Governor's Radiology
17900 Governor's Highway
Homewood, IL 60430

Re: Control No. 81529

This is in response to your letter of July 18, 1986 in which you requested additional information regarding the above-referenced materials license application. Following is the additional information:

Nuclear Imaging Room

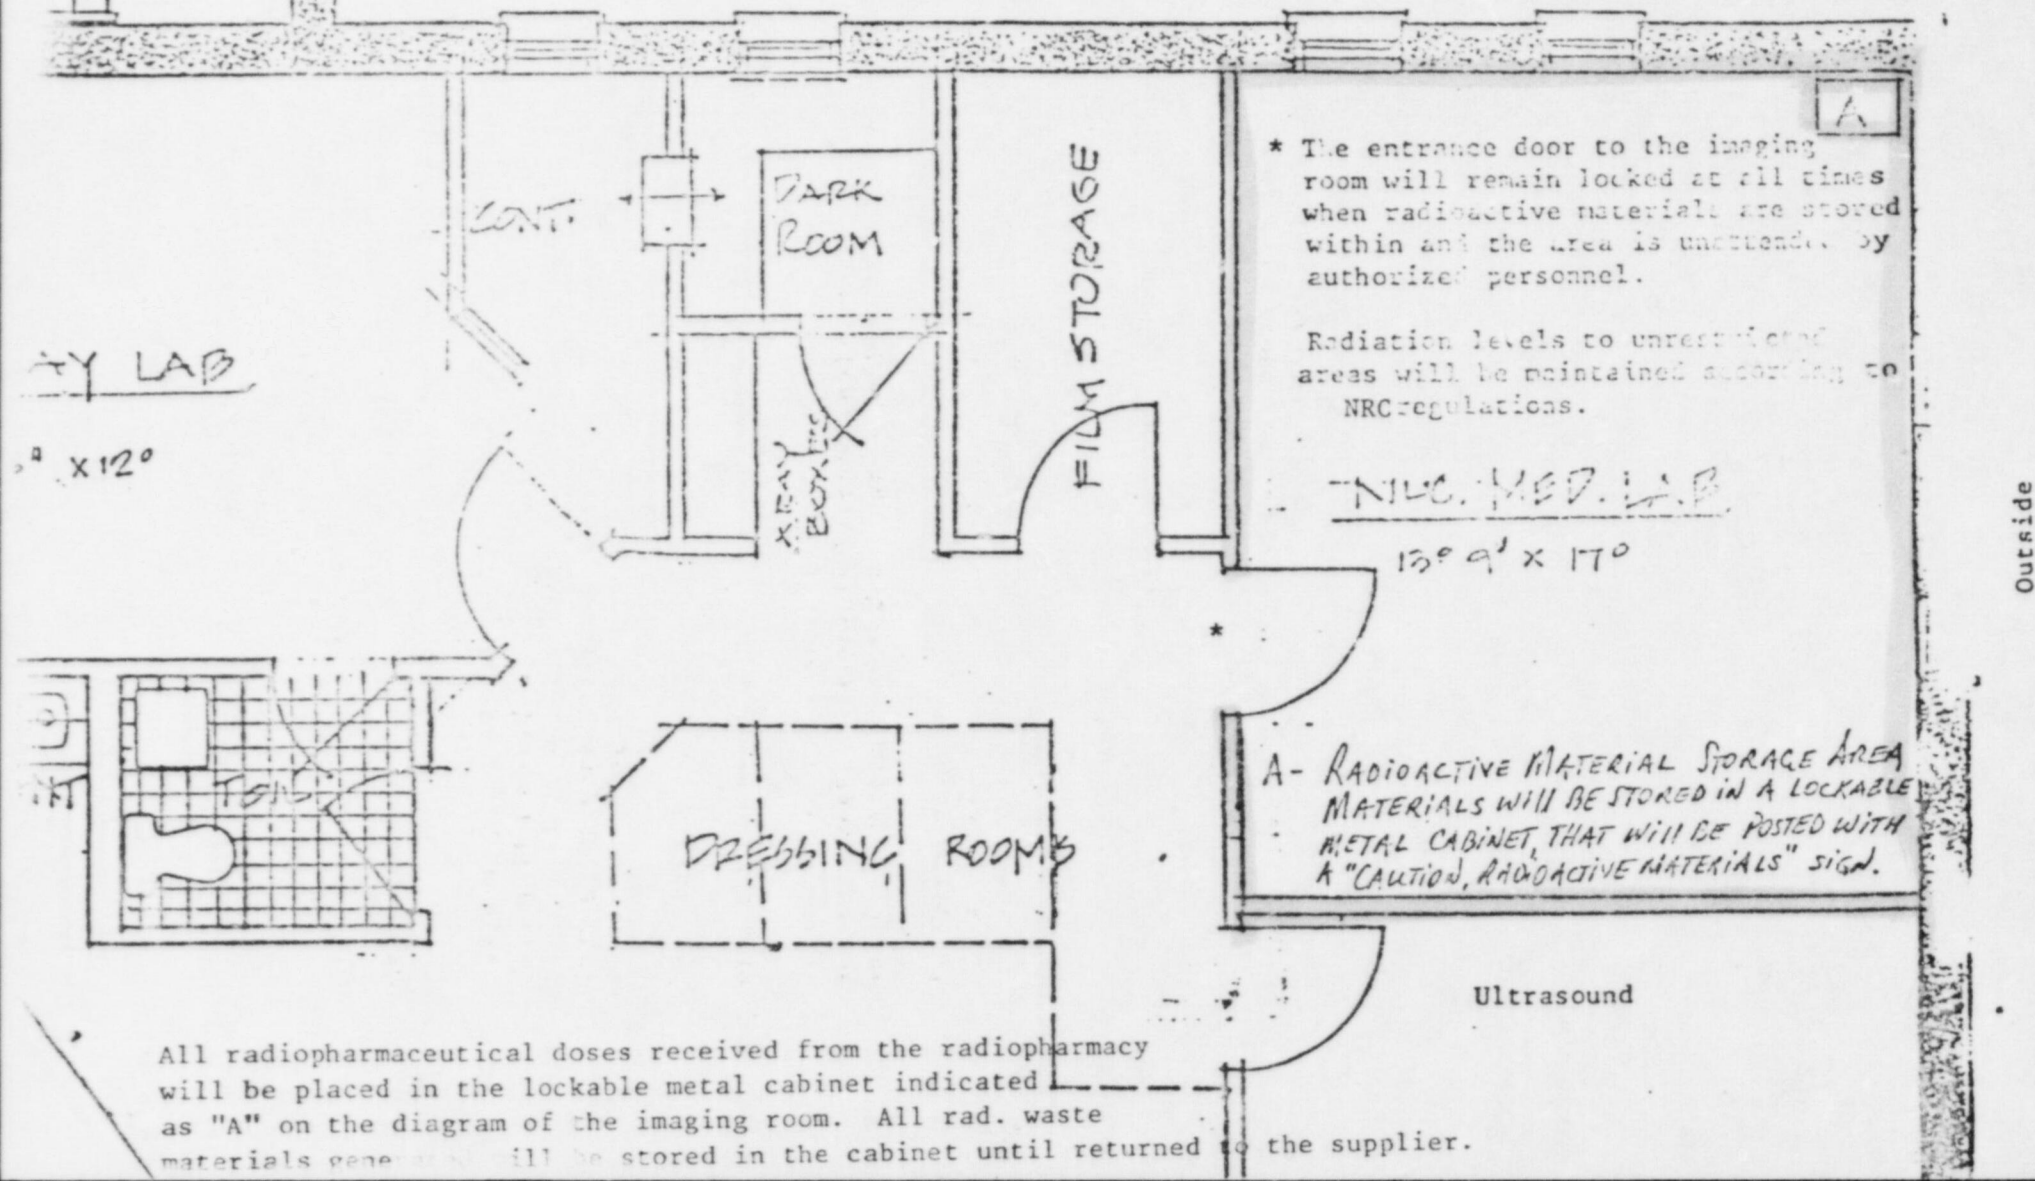
1. This is to confirm that I am Managing Owner of Governor's Radiology.
2. Attached is a more detailed diagram of the proposed nuclear medicine room. Please note, all radiopharmaceuticals received from the central radiopharmacy in unit doses will be stored in lead (Pb) containers provided by the supplier. Radiopharmaceutical doses will not be prepared in our facility. Radioactive waste materials generated at our facility will be returned to the supplier, on a daily basis.

Rad. waste materials will be stored in a lead (Pb) container of approx.

1/8" Pb. Such waste will be stored at "A".
Outside

All radiopharmaceutical doses received from the radiopharmacy will be placed in the lockable metal cabinet indicated as "A" on the diagram of the imaging room. All rad. waste materials generated will be stored in the cabinet until returned to the supplier.
